From: [REDACTED]
Sent on: Wednesday, September 20, 2023 9:01:00 PM
To: [REDACTED]
Subject: Re: DA20230727 - Submission - Development Application - 21C Billyard Avenue & 10 Onslow Avenue, Elizabeth Bay
Attachments: DA 2023 727 Darnley Hall 12 Onslow Ave Submission.pdf (6.88 MB)

Our Ref: Project 966
Your Ref: DA20230727

Re: Submission - Development Application

Property:, 21C Billyard Avenue & 10 Onslow Avenue, Elizabeth Bay (the development site)

Figure 1 - View line over the development site to Darling Point

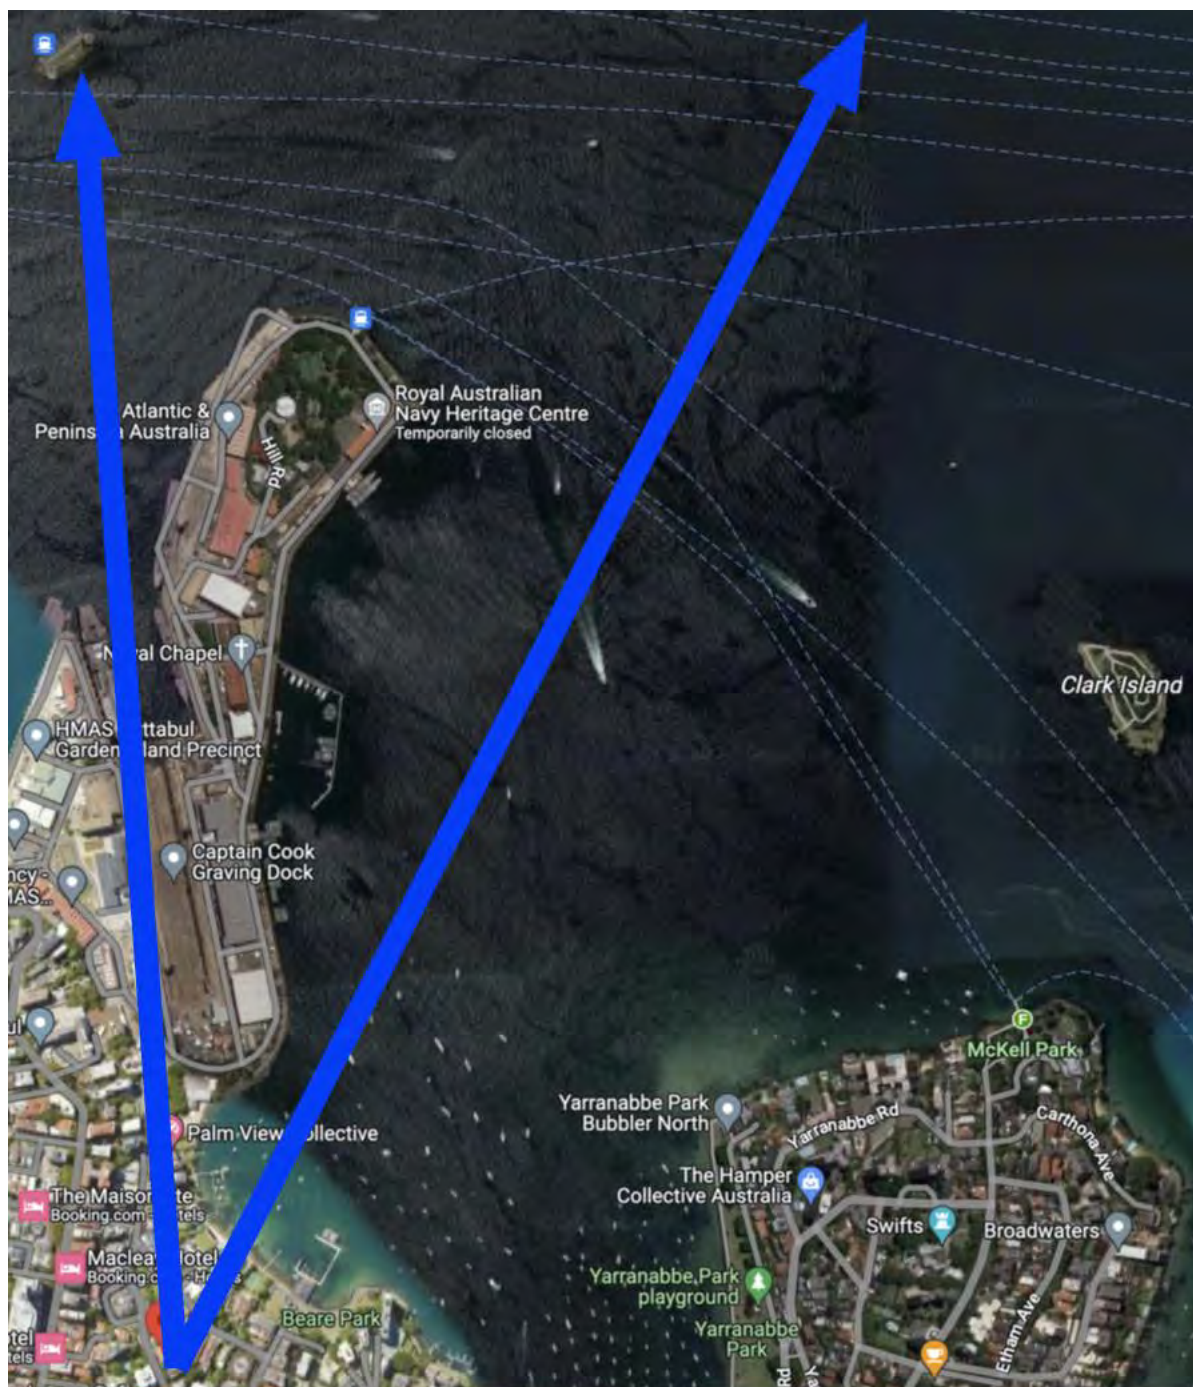
- Severe a loss of iconic, water and land-water interface views north of the site over Garden Island to Fort Denison and to the north-east from the upper levels of **Darnley Hall** caused by a breach of the maximum 22m HOB under *Sydney Local Environmental Plan 2012* (LEP) by the proposed western tower.

- Severe a loss of water and land-water interface views north-east of the site to the northern foreshore of Elizabeth Bay and beyond to Bradleys Head's land-water interface from the lower levels of **Darnley Hall** caused by a breach of the maximum 15m HOB under *Sydney Local Environmental Plan 2012* (LEP) by the proposed western tower.

The existing views are very high amenity and highly cherished element of the views from Darnley Hall and, for that matter, all residential buildings within the immediate vicinity of the development site. Darnley Hall have procured a detailed Visual Impact Assessment by Urbaine Design Group Pty Ltd. I note that the impacts identified have been based upon the built form and the height exceedances, upon a height plain claimed by the Applicant. I submit that the Applicant's Height Plain is wrong, and I rely upon Figure 2 below.

Figure 2 - Correct HOB Applying Merman Approach

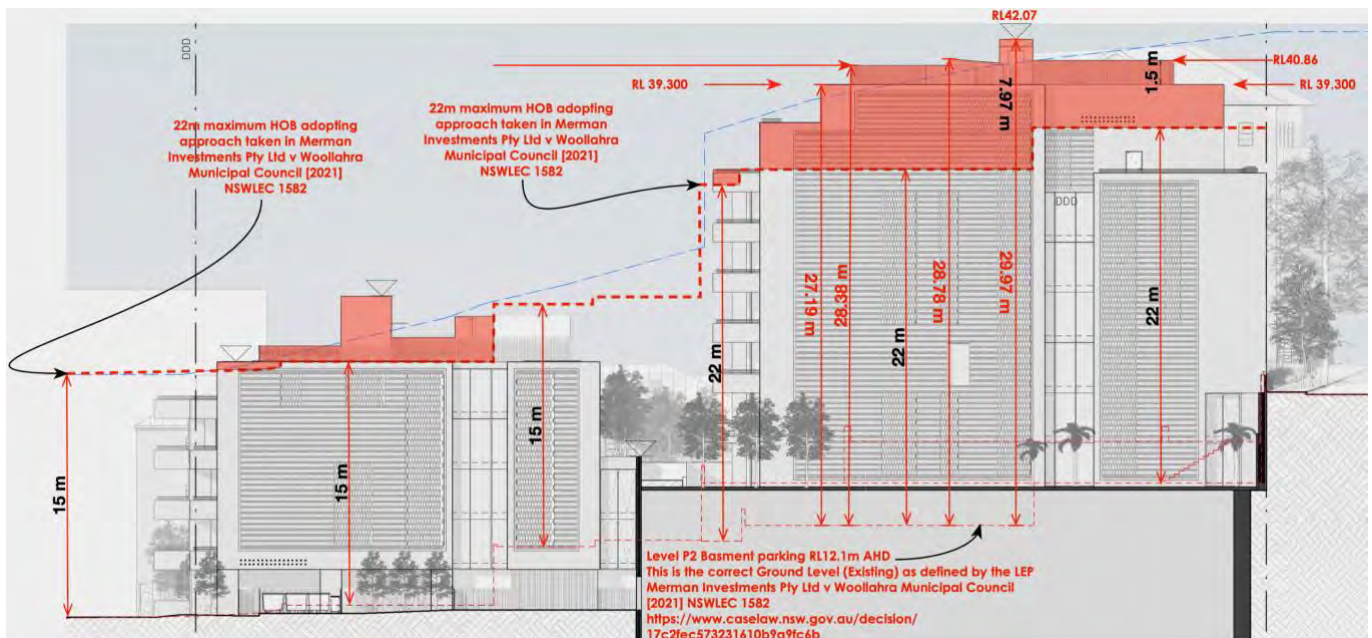
3. The clause 4.6 does not correctly calculate the HOB applying the definition of HOB in the LEP. The clause 4.6 adopts the approach in *Bettar*⁴ whereas the later approach taken in *Merman*⁵ is the correct test that should be applied.

7. The loss of solar access to most apartments in Darnley Hall is severe, and the exceedance of the HOB is the major contributor to the impacts.

The crux of the Applicant's justification for the clause 4.6 is that the exceedance is required to provide equitable access to roof top private open space (POS). In the first instance it must be noted that the penthouse is provided with ADG compliant POS at the level below the roof top POS proposed. There is no reasonable necessity to provide additional roof top POS. Whilst this would be nice for future occupants and no doubt increase the value for the sale of this unit for the Applicant, the planning question, applying the *Davies Planning Principle*⁶ is "How reasonable is the proposal causing the impact?"

Taking away views from many neighbours to provide a very high amenity outcome for one penthouse, by creating roof top "private" open space, exceeding the HOB, is not reasonable. The provision of excessively high screens and an excessively high lift overrun 4m above the 15m HOB is also unnecessary and unreasonable. The 4m high lift overrun on the eastern Billyard Ave building is unnecessary and unreasonable along with the high screens to the roof top COS. These elements all breach the 15m HOB and are the cause a sever loss of views from the lower levels of Darnley Hall.

Figure 3 – East elevation, indicating height exceedance in red overlay. Smart Design Studio.

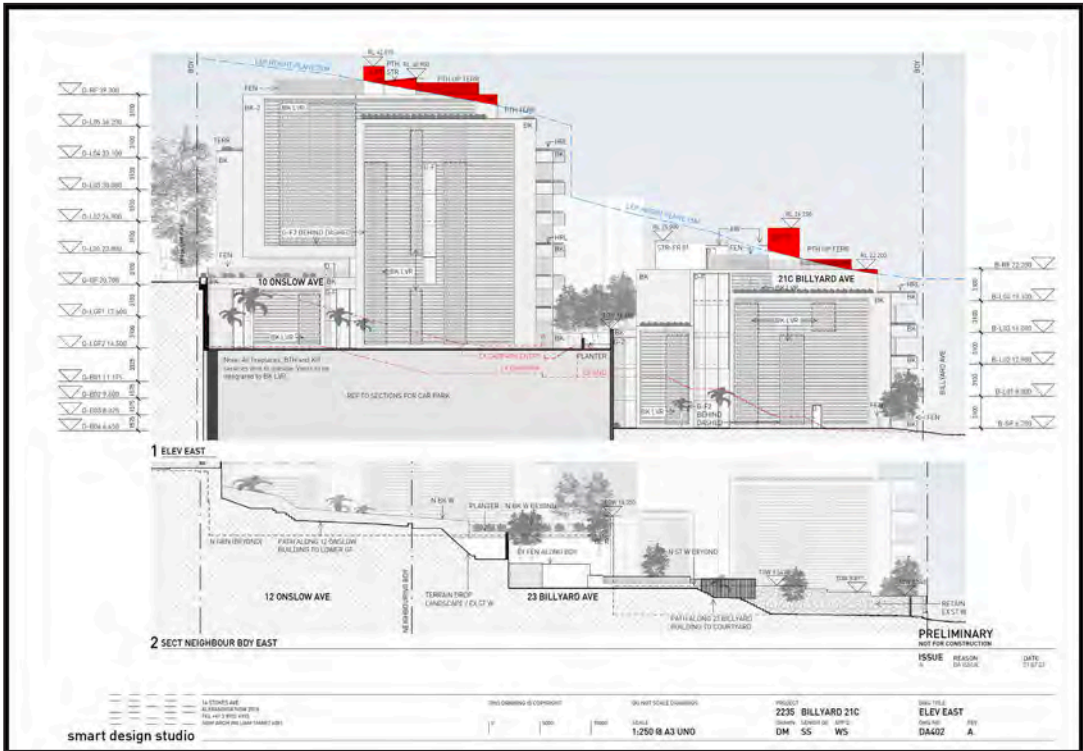
- First, the existing ground level they are using is incorrectly high. It should be 12.1m
- Secondly, the height plane should be flat, not sloped, as the existing ground level is flat. The ground level only steps up to 14.7m when it is 14m from the Onslow Ave boundary (when measured from the north side), when it is then flat again.
- This results in an excess of 7.97m at the maximum discrepancy. A 36% height overrun.

- The height plane should be flat, not sloped, as the existing ground level is flat. It then steps upwards at the far western edge of the block, then is flat again.
- This results in a 4 meter overrun along the centred half of the building. Only half of the staircase exit at the western end is under the limit.
- The elevator overrun is exceptionally large.
- The elevator overrun should not be in the position that blocks the majority of the affected views from Darnley Hall.
